# Monument Ridge East Preliminary Plan

**Letter of Intent**

PCD File No: SP241

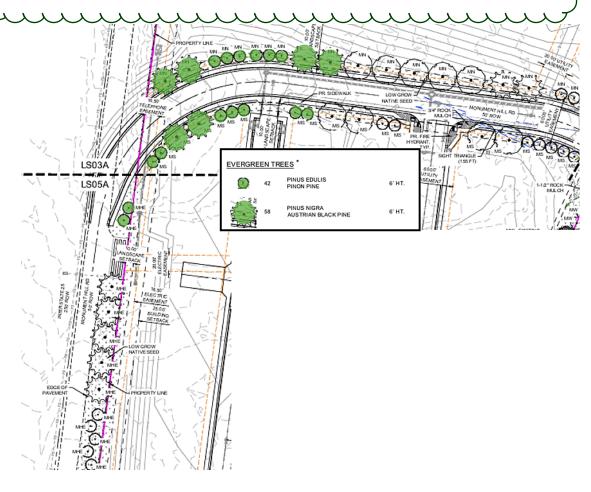
Your noise study states a waiver is being requested for the required noise wall.

Include additional setbacks on the plat

In the event that building setbacks or orientation standards are utilized as the mitigation strategy, those building setbacks and orientation standards shall be noted on the plat.

# Subsection 8.4.2.B(2)(b)(i) Analysis: No Waiver Needed – Mitigation Proposed

The associated Noise Impact Study projects that a small, isolated area of the project nearest to the extension of Monument Hill Road may experience noise levels slightly in excess of the standard of 67dBA. Those exceedances have been projected to amount to 2.6, 4.1, and 1.4 dBA for receptors 12, 13, and 25, respectively. For this reason, the applicant is proposing to install a landscape buffer and berm along the western boundary of the property. More specifically, the proposed landscaping in the area of the potential noise exceedance is proposed to include only evergreen plantings in the form of 6-foottall Austrian Black Pines and 6-foot-tall Pinion Pines (both highlighted in green) as depicted below in a selection from the associated preliminary landscape plan:
